CITY OF NEWBURYPORT
DEPARTMENT OF PUBLIC SERVICES

MEMORANDUM

SUBJECT: Graf Road Medical Facility – Site Plan Review
Engineering Review Comments

We provide the following comments to the subject project. These comments are based on the Plans titled *Site Development Plans, Proposed Medical Building, 20 Henry Graf Jr. Road in Newburyport, Massachusetts*, Plans dated April 29, 2020, Rev 1.

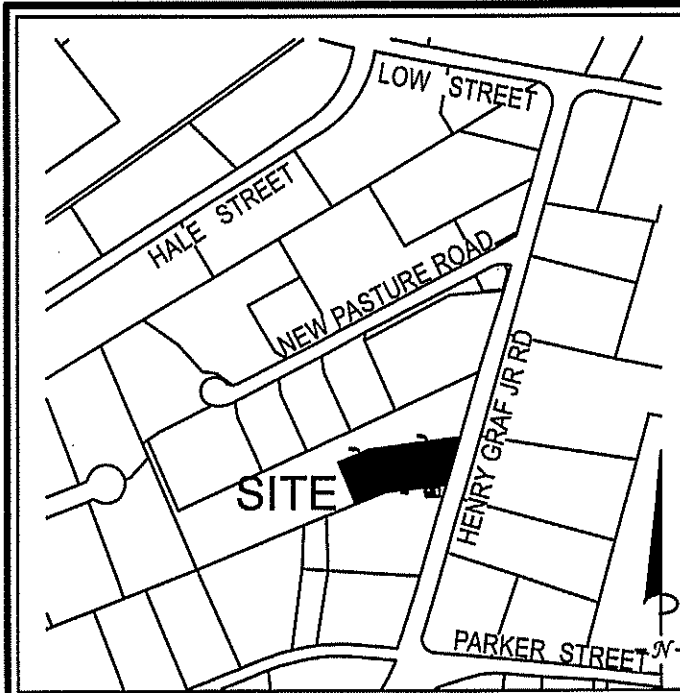
In this case, the guard rail will have to be removed or realigned in order to properly fit the sidewalk. If it remains, then the back of the sidewalk will be overhanging into the swale, thereby requiring a steeper sideslope of the swale, which will require a fence or guard rail to prevent people from falling in. That would require a wider area at the back of sidewalk to install it, which results in more

DWG. NO.: **C-1**

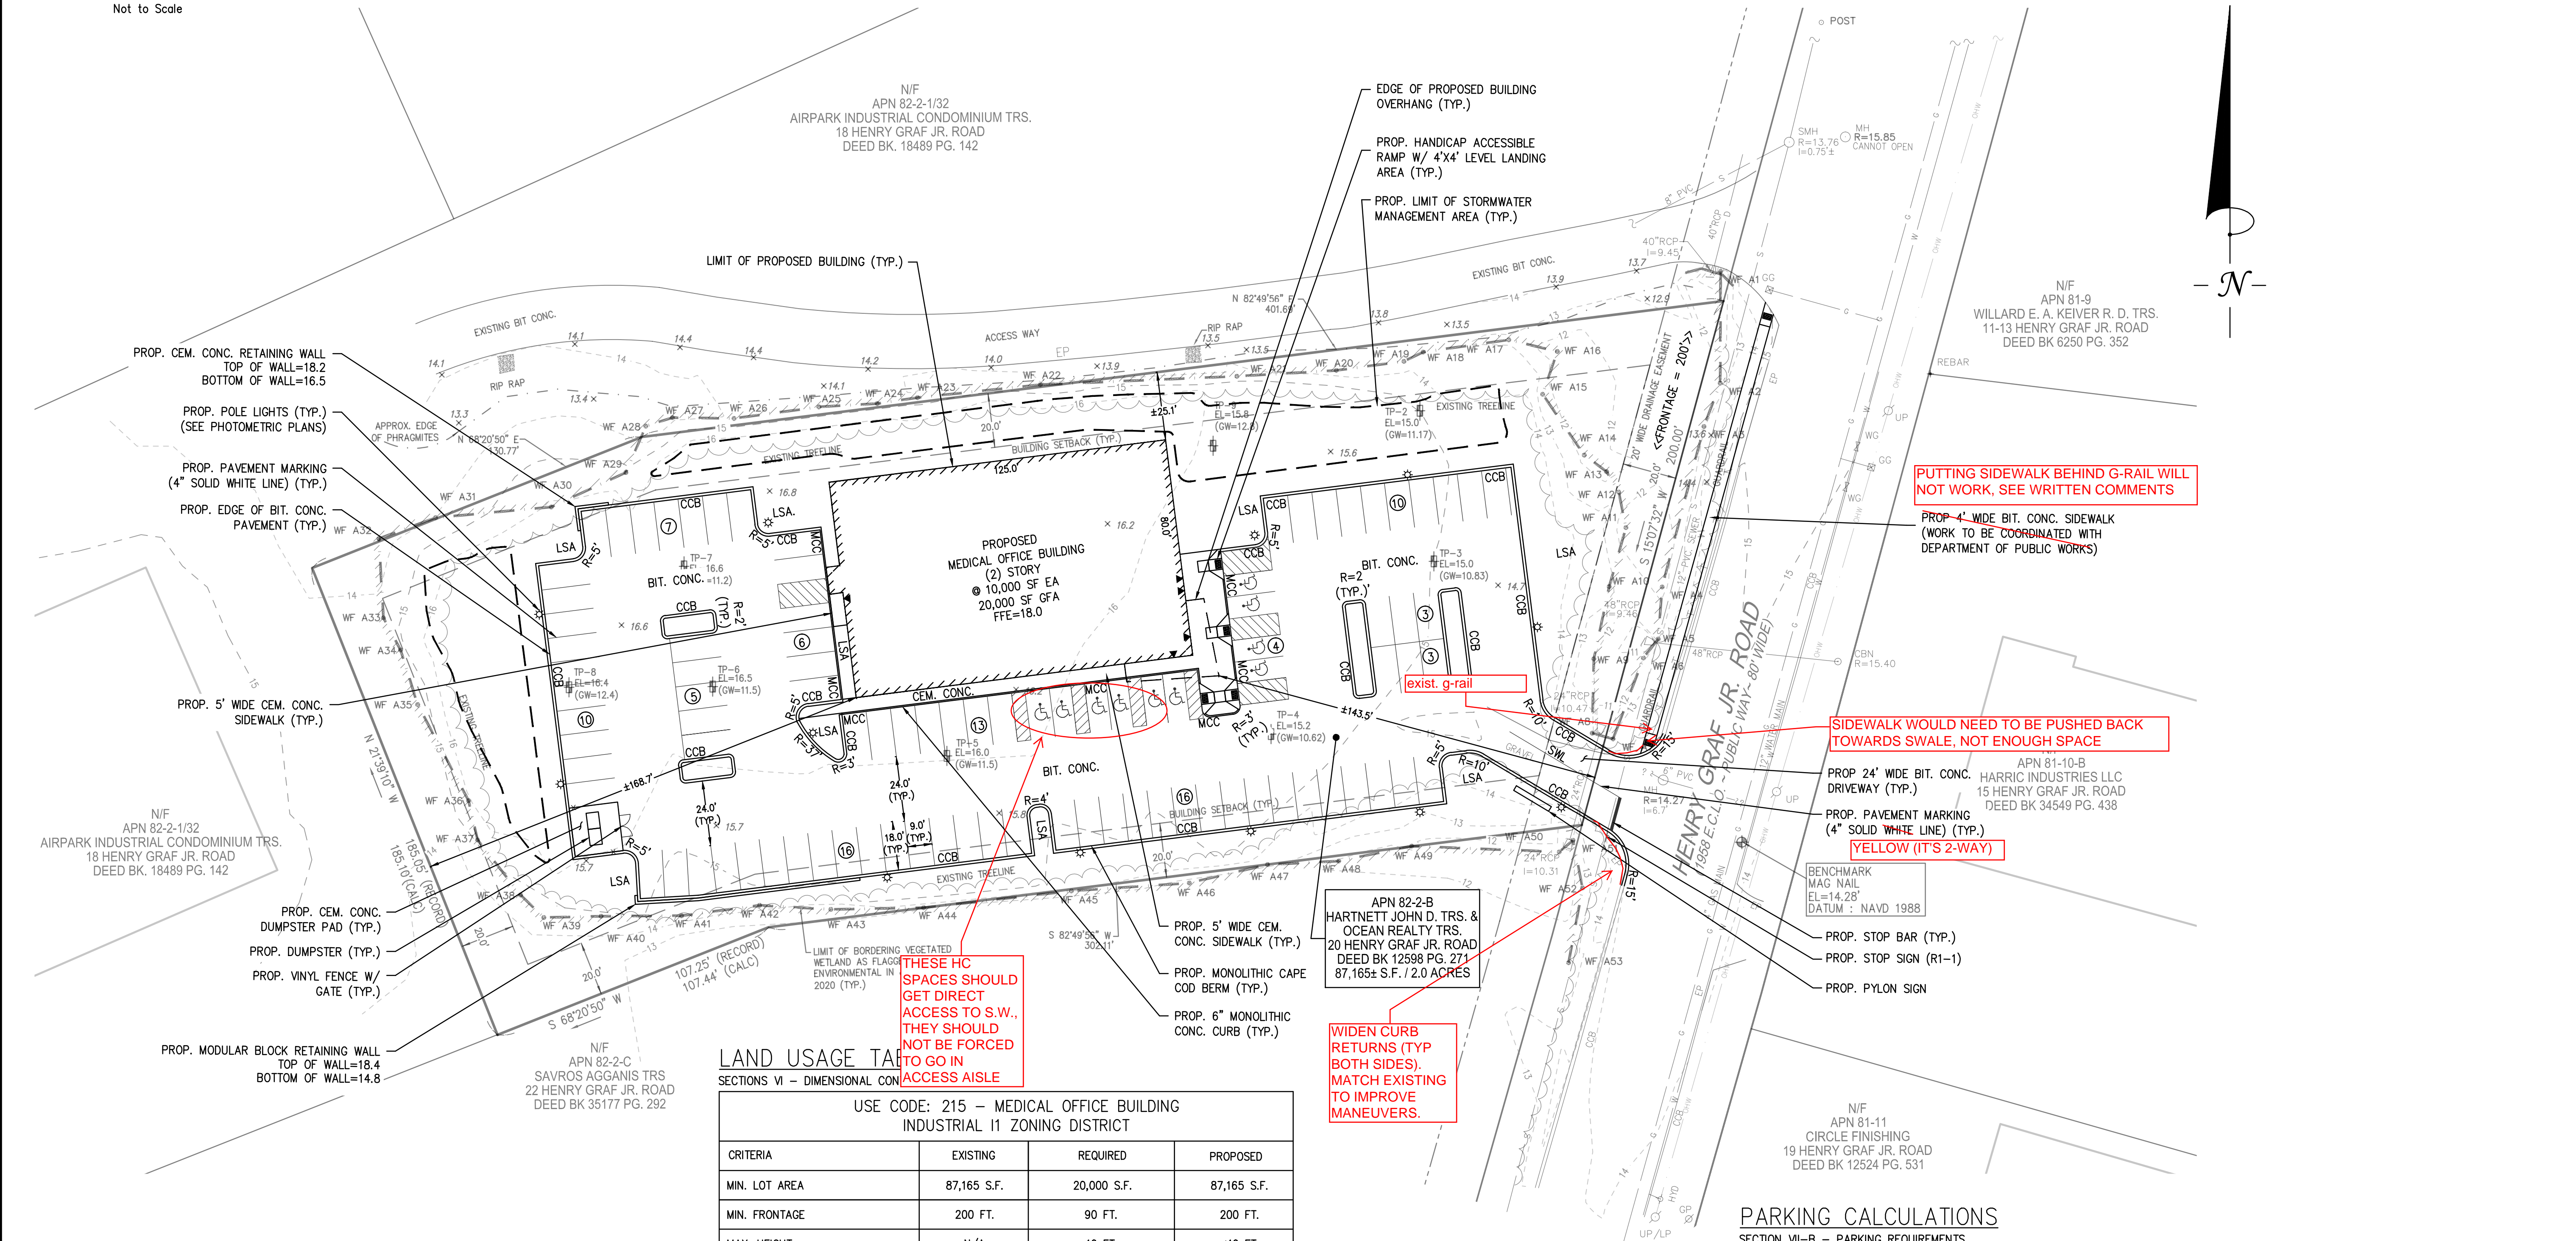
Sh C-1 Site Layout Plan:

- We recommend not installing a sidewalk. The City's requirement that new developments install sidewalks is applauded in concept but it is very difficult to achieve on roads that currently do not have any. Piecemealing sections of sidewalk inevitably results in constructing them in an improper horizontal location but more importantly, an improper vertical location. Future sidewalks on either side will likely have difficulty meeting this sidewalk's location without reconstruction, for numerous reasons. The result is an inconsistent roadway cross-section that may not function properly and will certainly look dysfunctional.

steepening of the sideslope, which reduces the hydraulic carrying capacity of the swale, so a wall will end up being needed. With every wall come risks.

DWG. NO.:
C-2

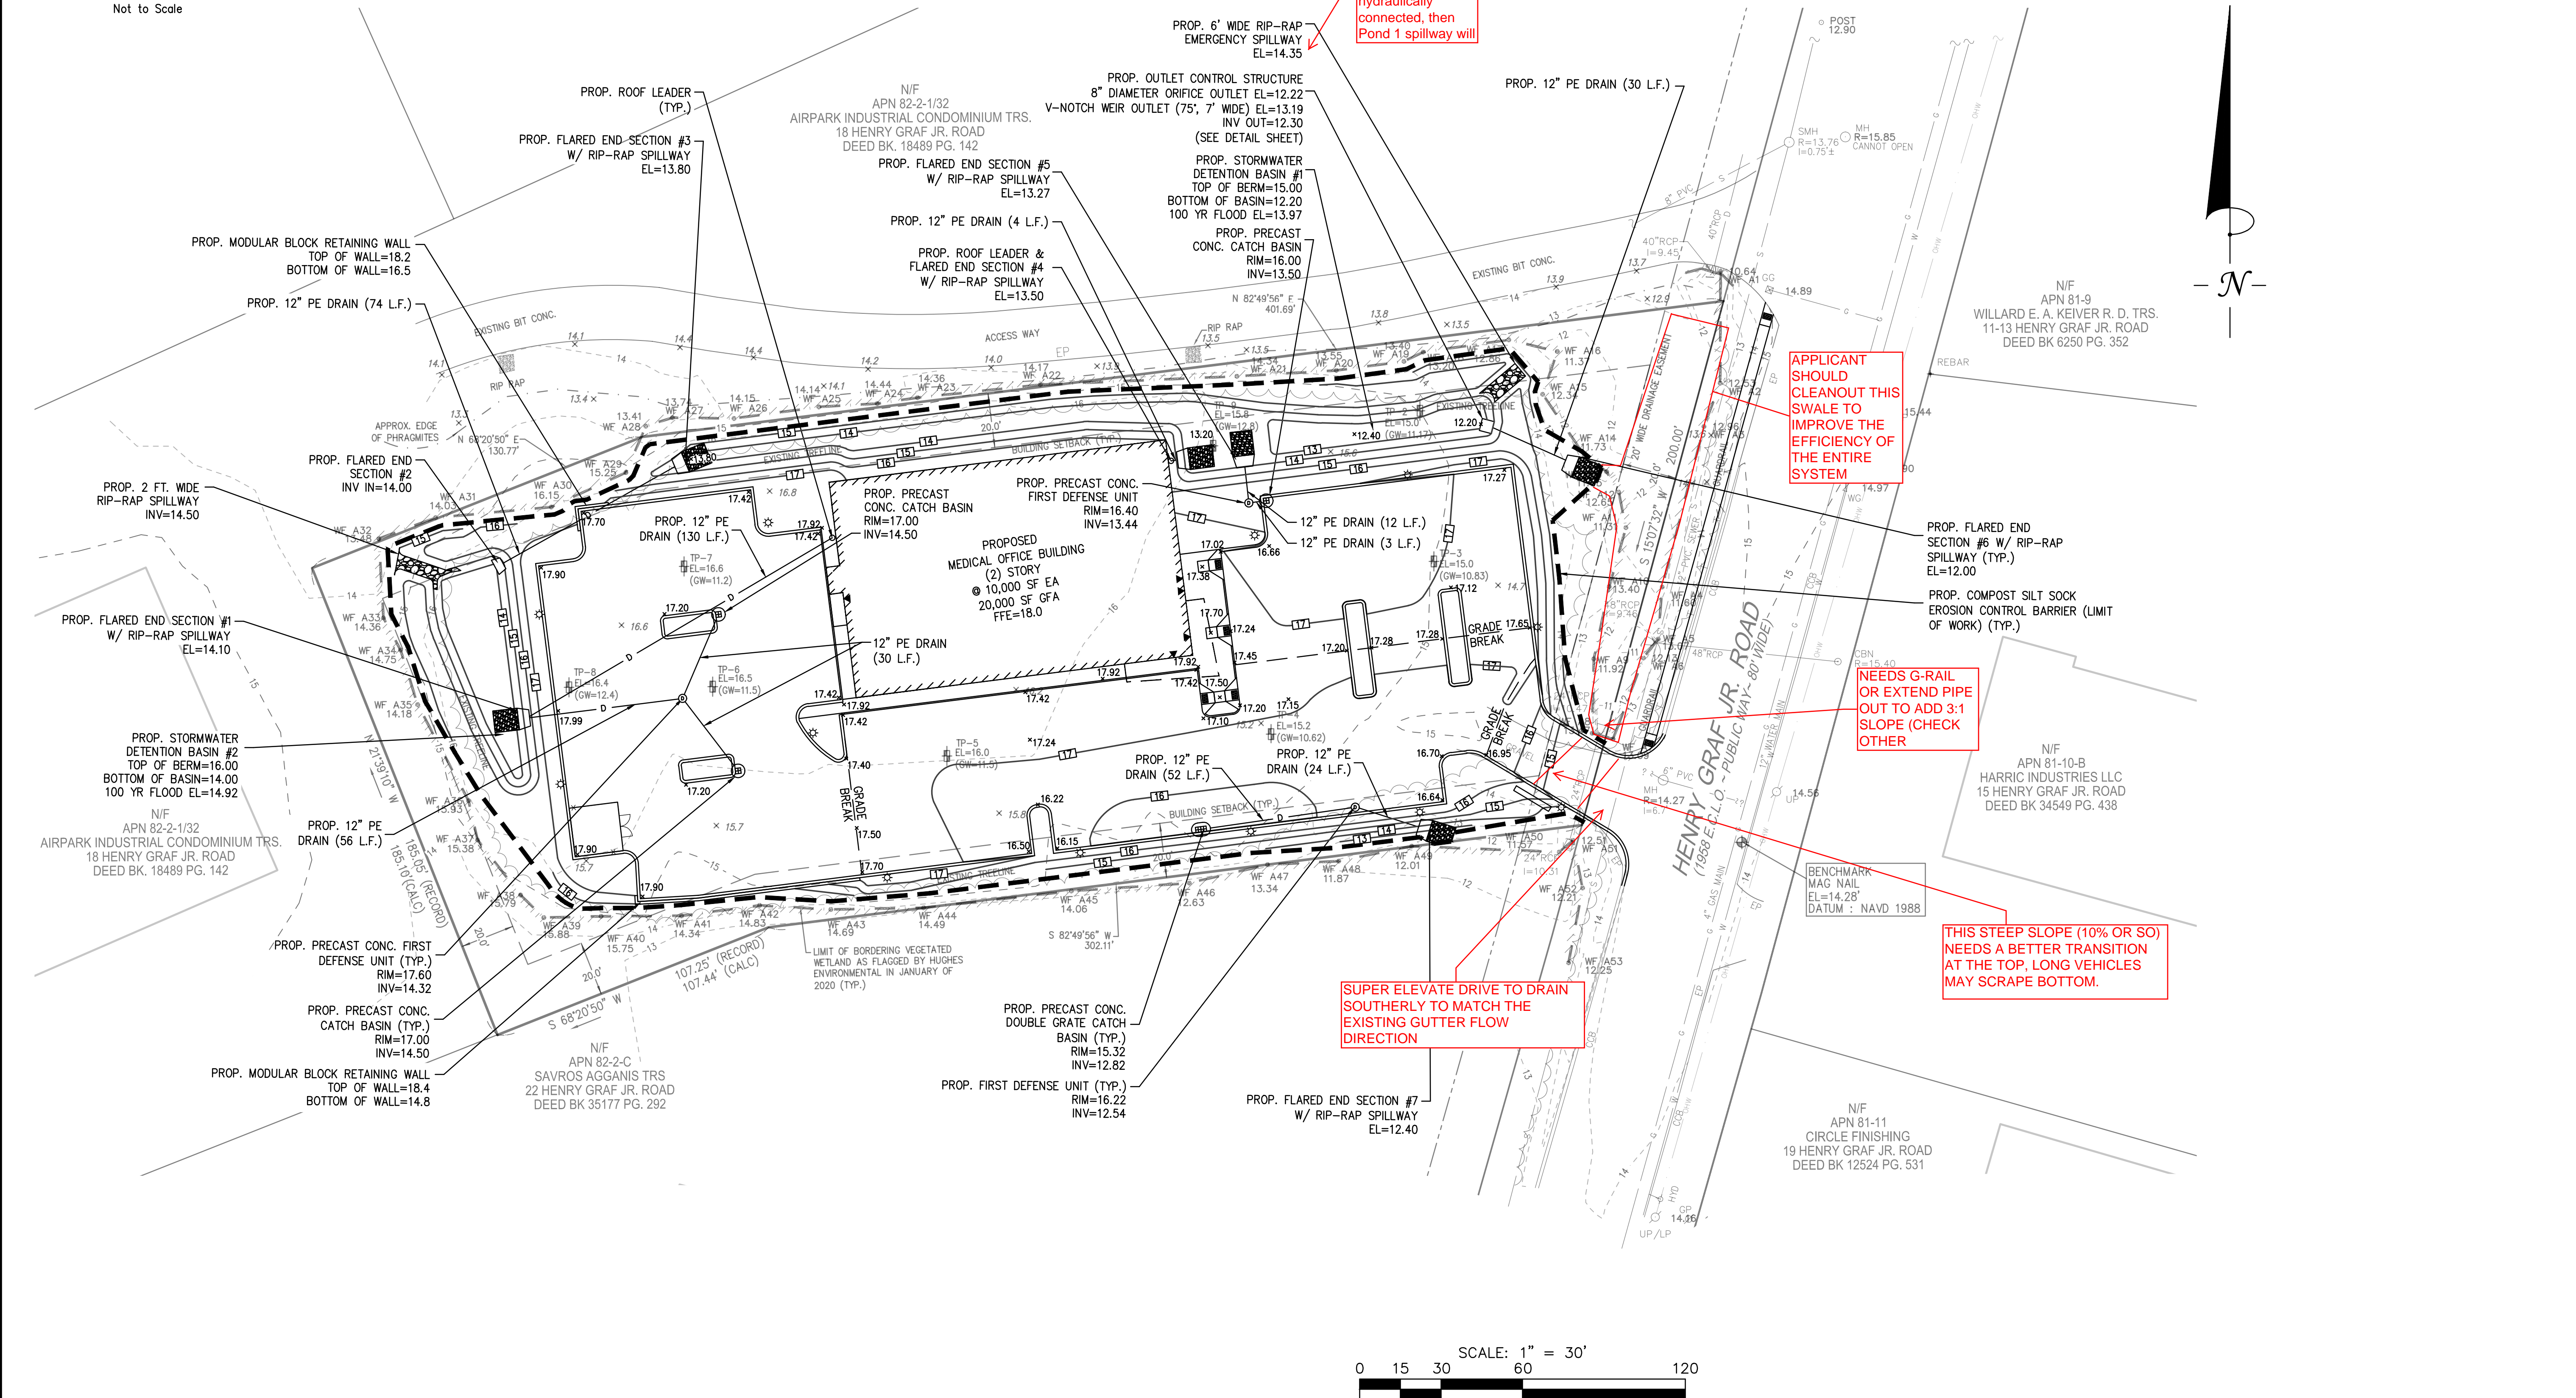
Sh C-2 Grading and Drainage Plan:

- The driveway entrance has approximately a 10% grade with virtually no vertical-curve type of transition at the top. I do not need to see a profile but this should be flattened out to prevent long trailers from bottoming-out.
- A guard rail is needed on both sides due to the drainage culvert below the drive. I highly recommend to extend both culvert ends and re-grade the sideslope to 3:1. This will prevent a wall to support the guardrail and these types of walls are an unnecessary expense. The ConCom should allow work within this swale.
- The gutter in Graf Road should be maintained to the same grades and the driveway should be superelevated in the same direction (southerly) so the driveway entrance doesn't result in a long, flat area that will pond. ADD a note to the drawing.
